Mixed Industry and Business Development – 101 Wongawallan Drive, Yarrabilba RFI Response

Lot 27 Wongawallan Drive, Yarrabilba
Swept Path Assessment

AMENDED IN RED

Amber 05

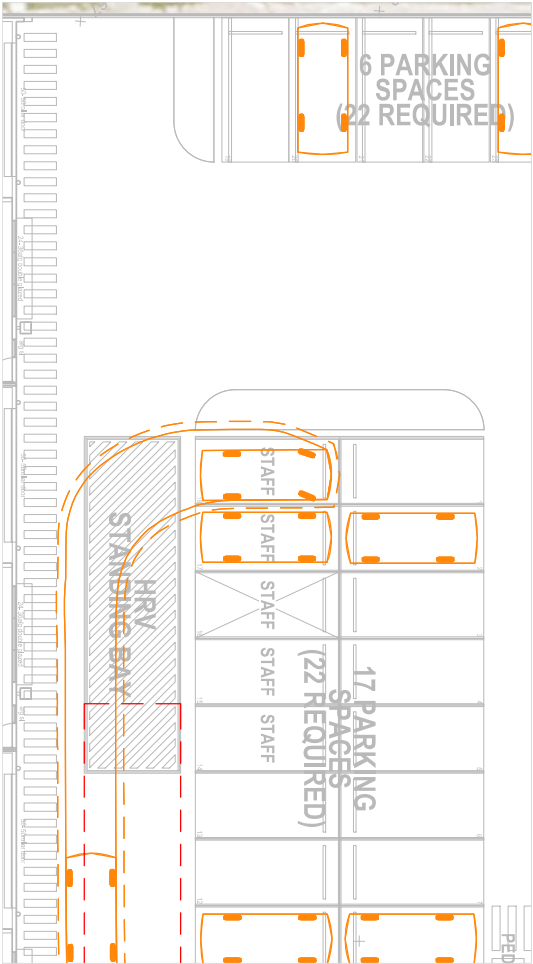
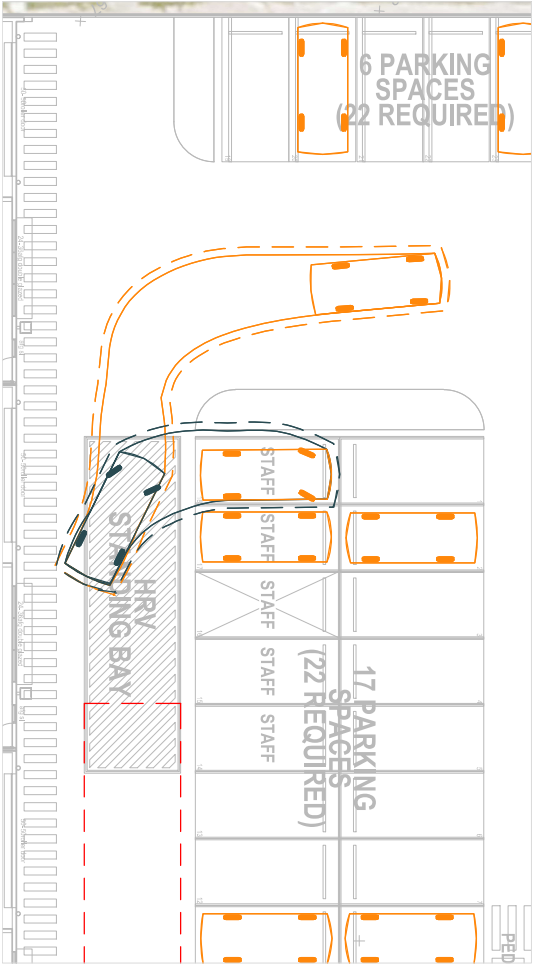
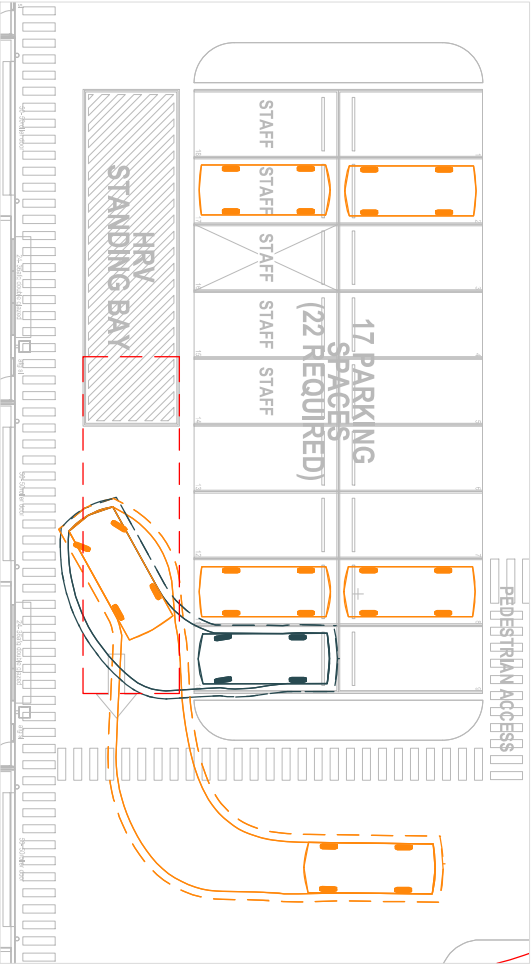
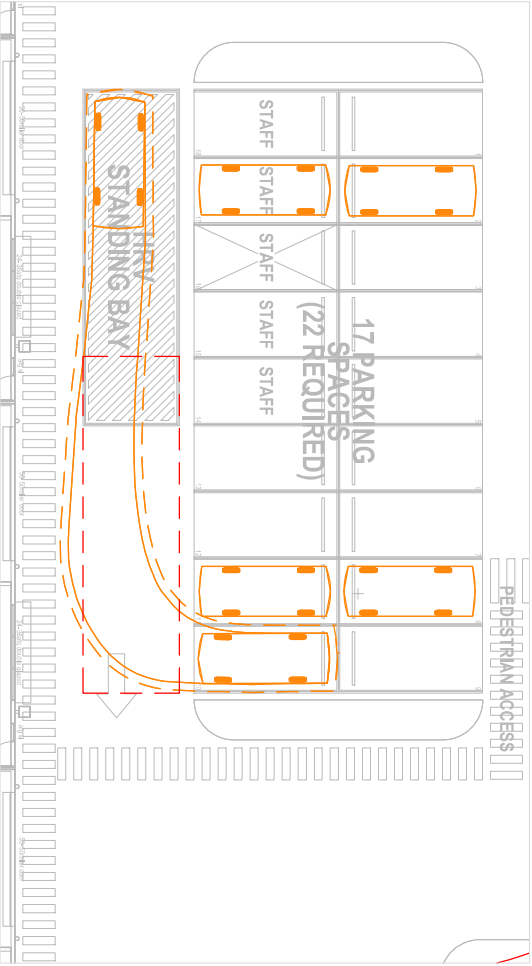
Entry and exit crossovers to be swapped

DRAWN: RK
DATE: 02/07/2026
DWG NO: 1624 S04A
SCALE at A3: 1:200

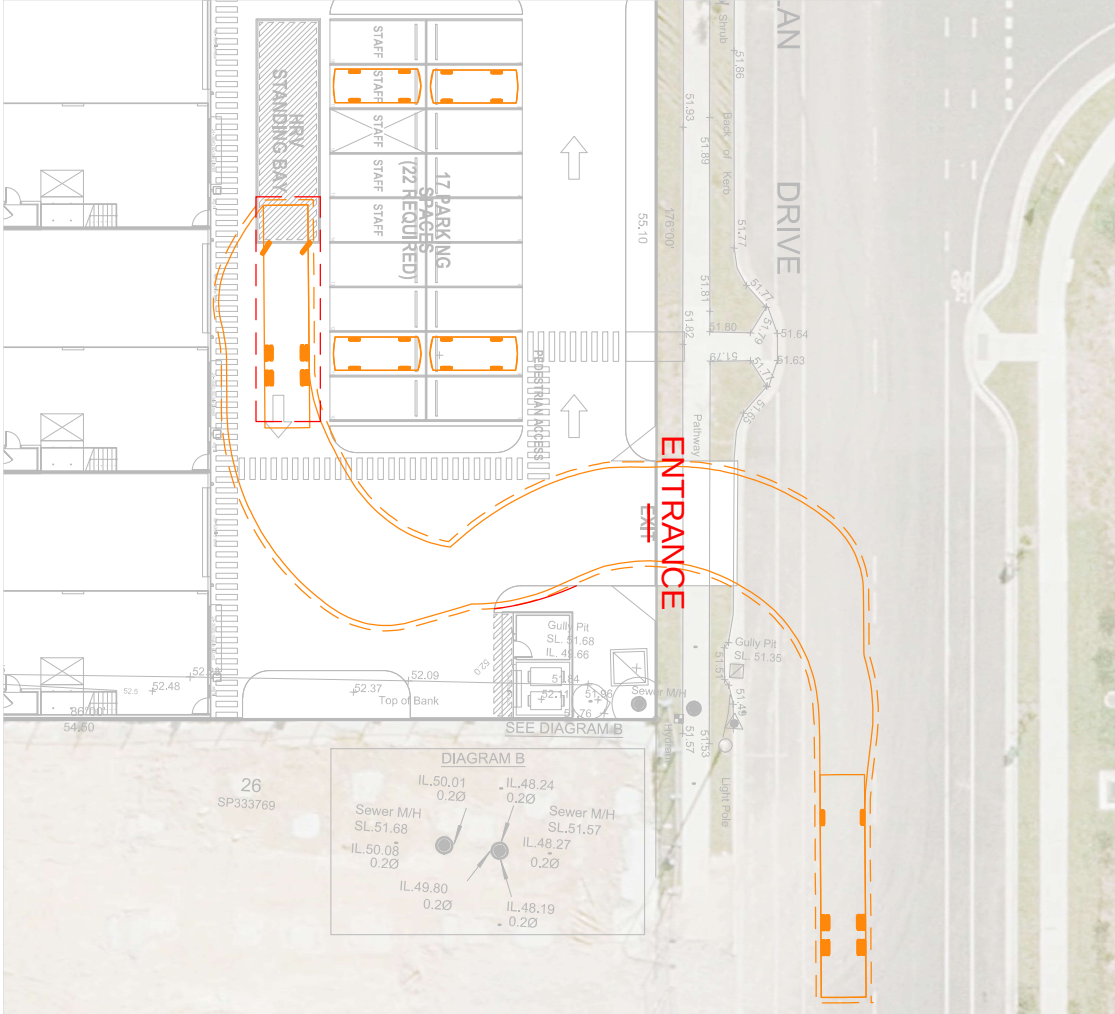
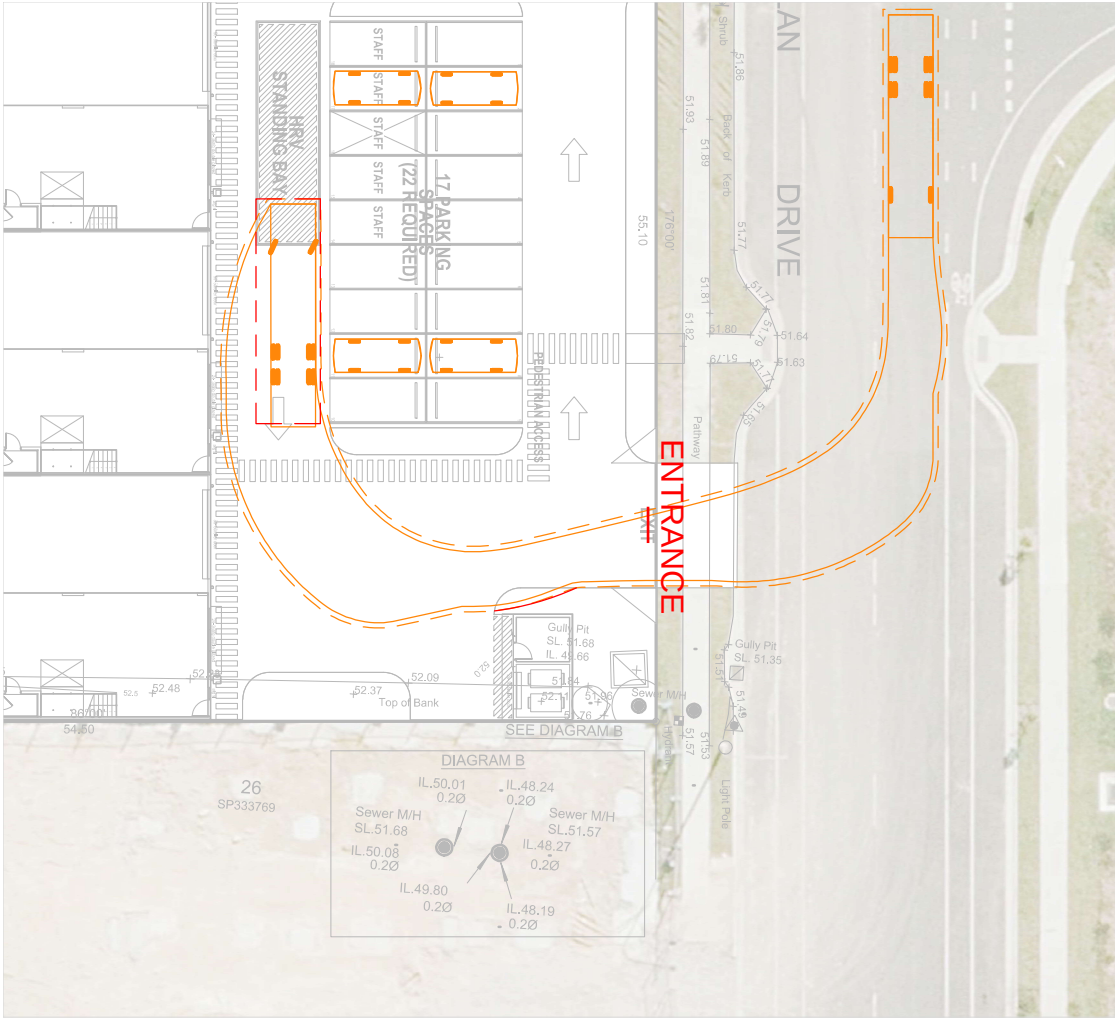
Entry and exit crossovers to be swapped

Amber 08

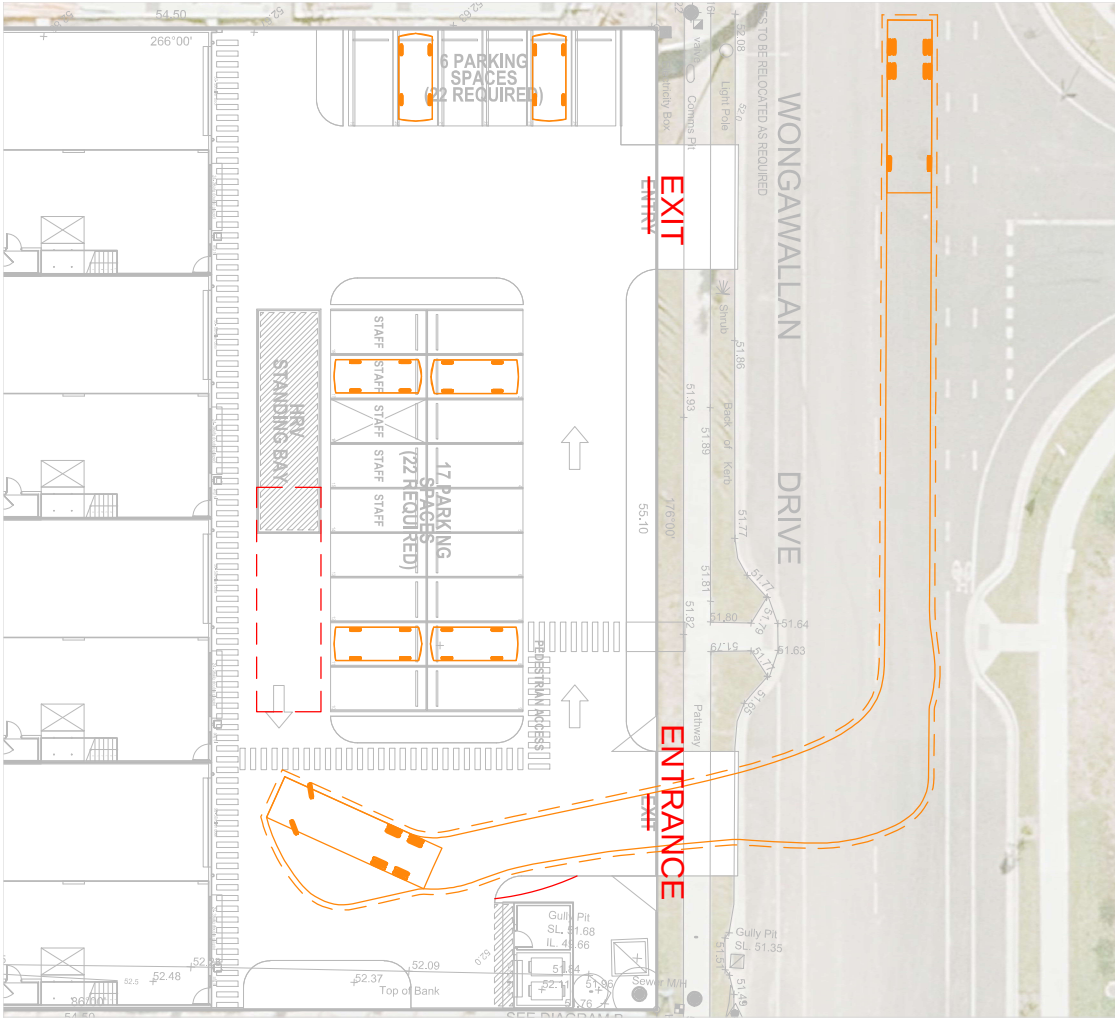
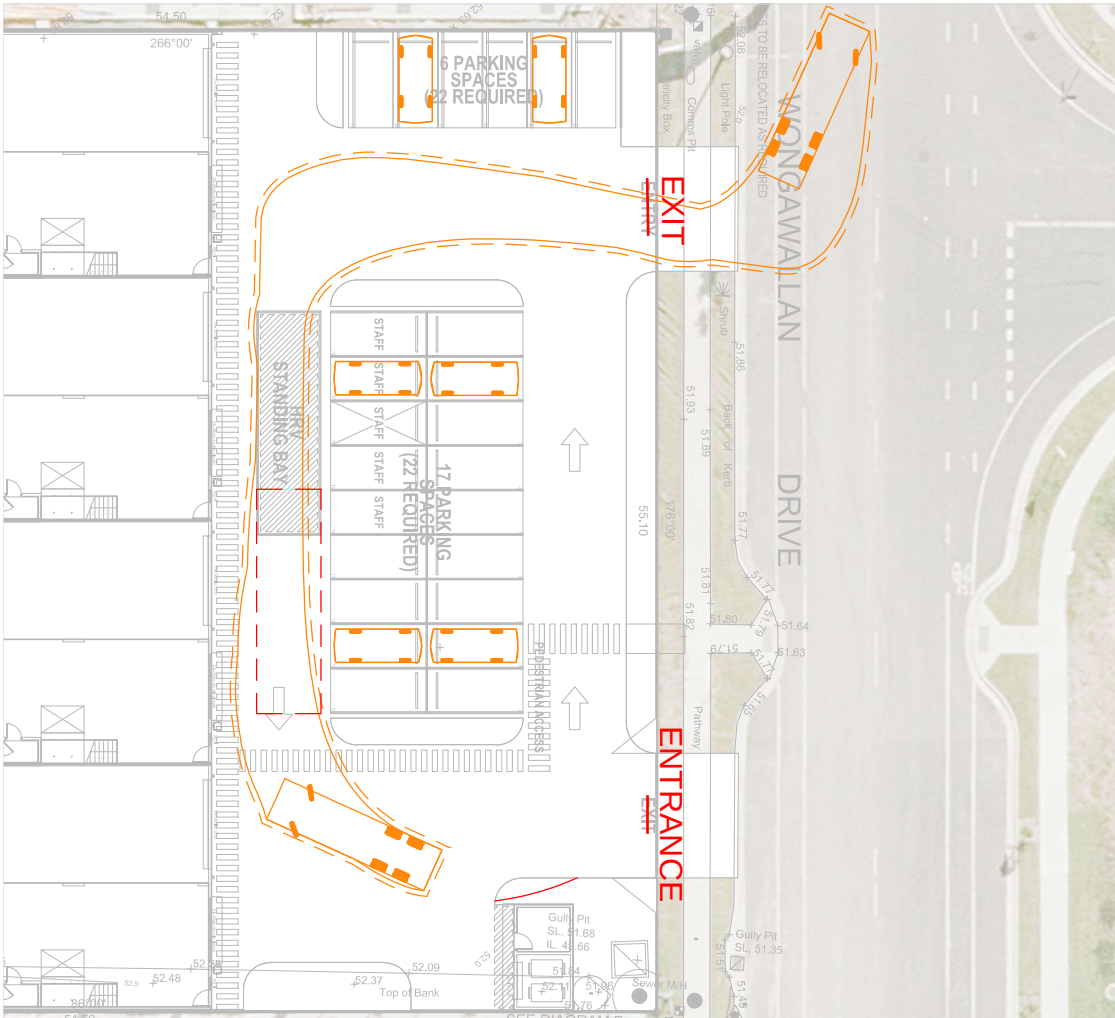
Entry and exit crossovers to be swapped

Amber 09

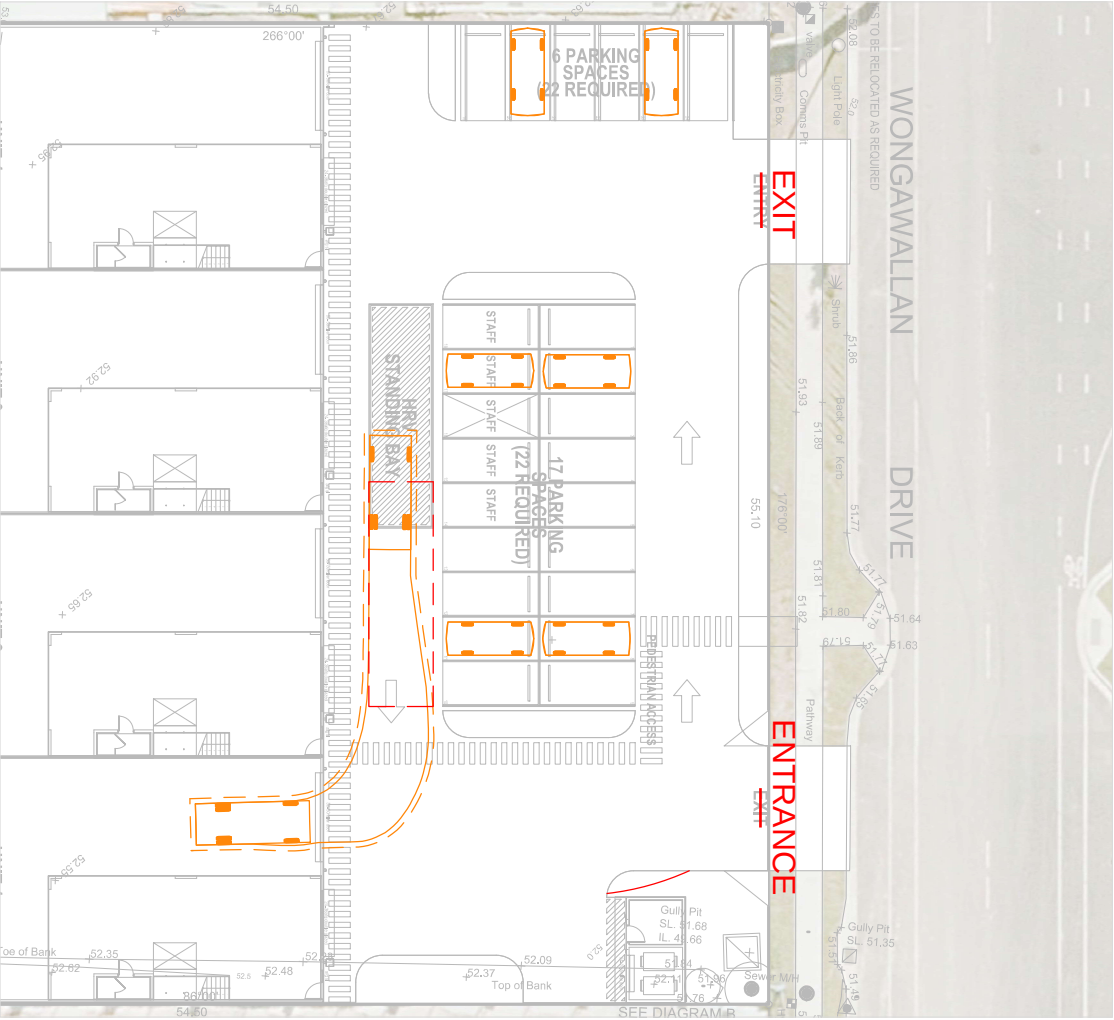
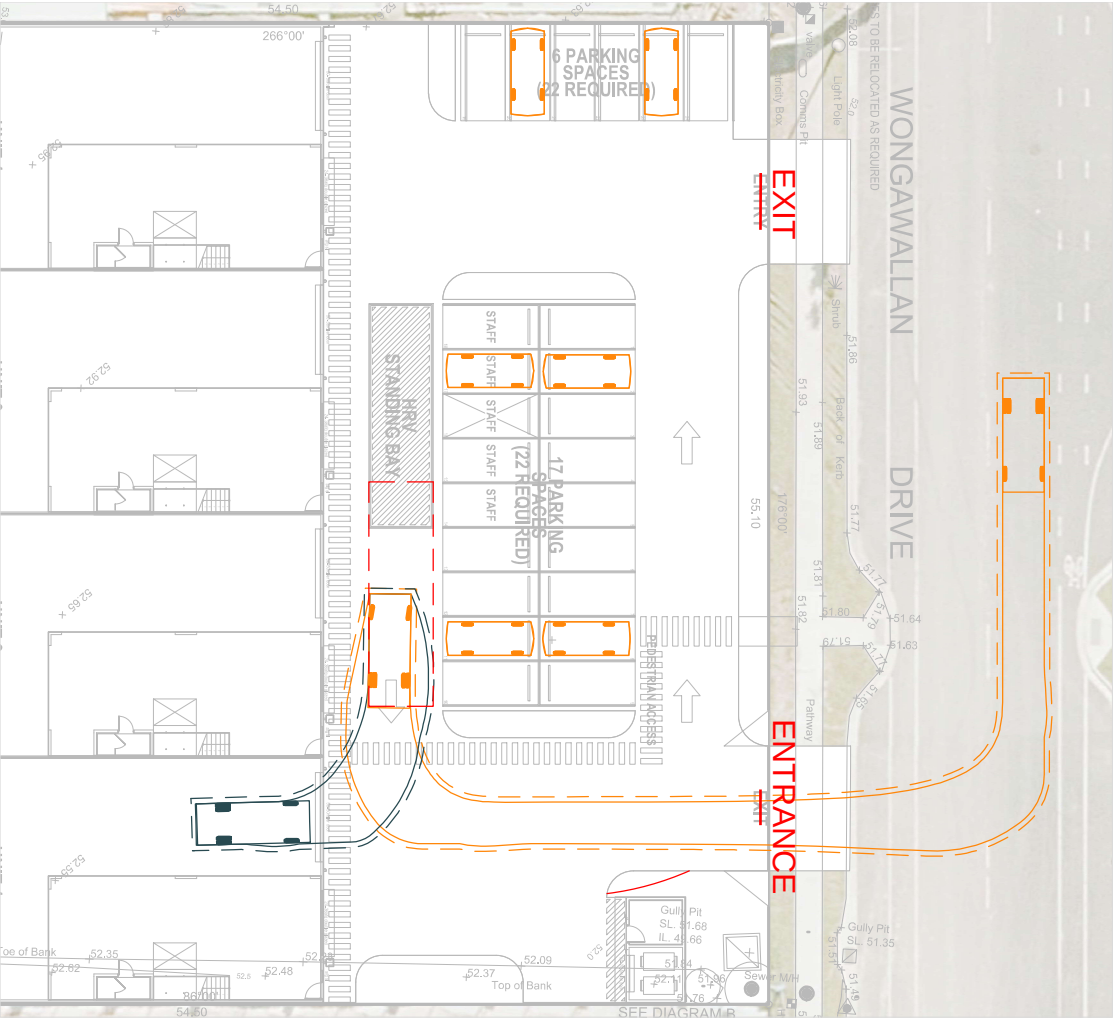
Entry and exit crossovers to be swapped

Amber 10

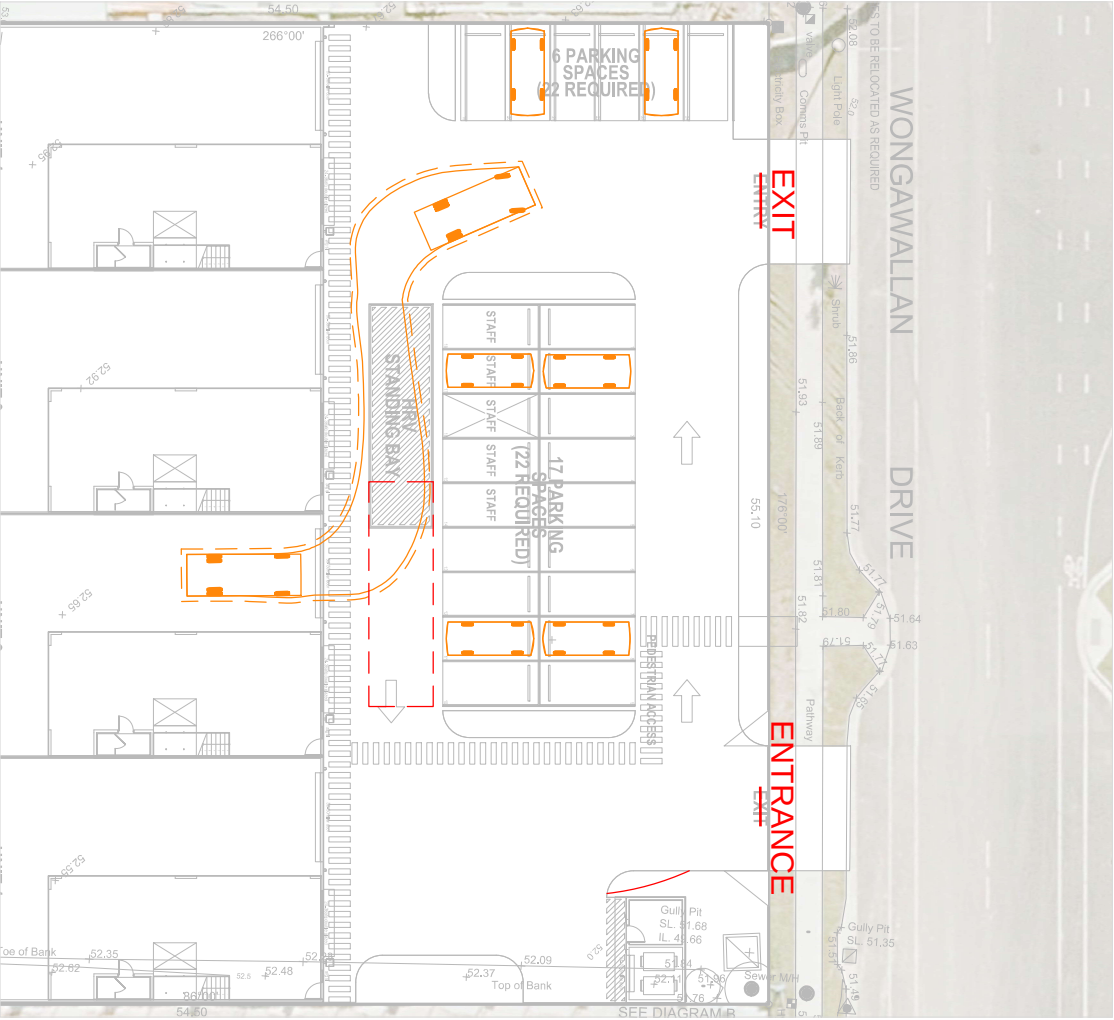
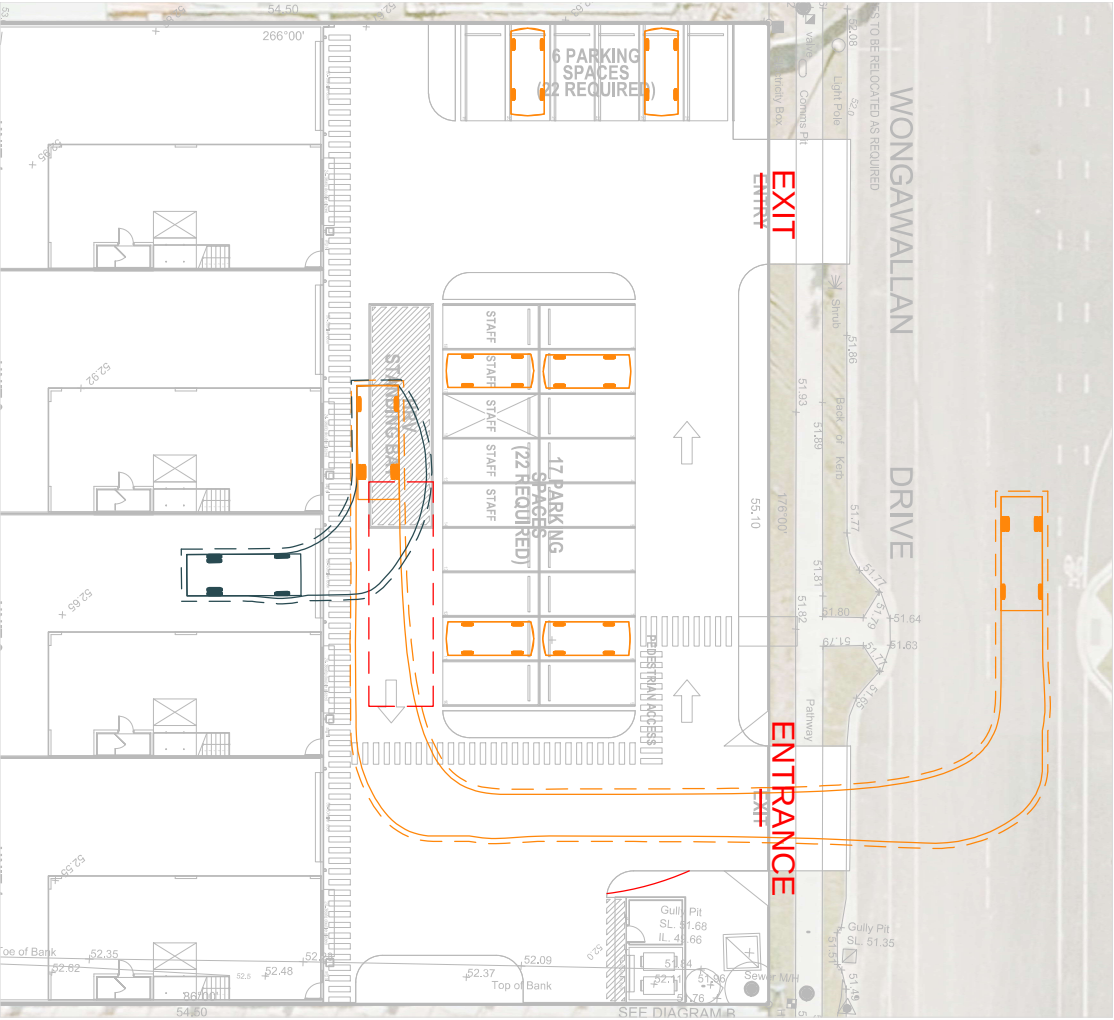
Entry and exit crossovers to be swapped
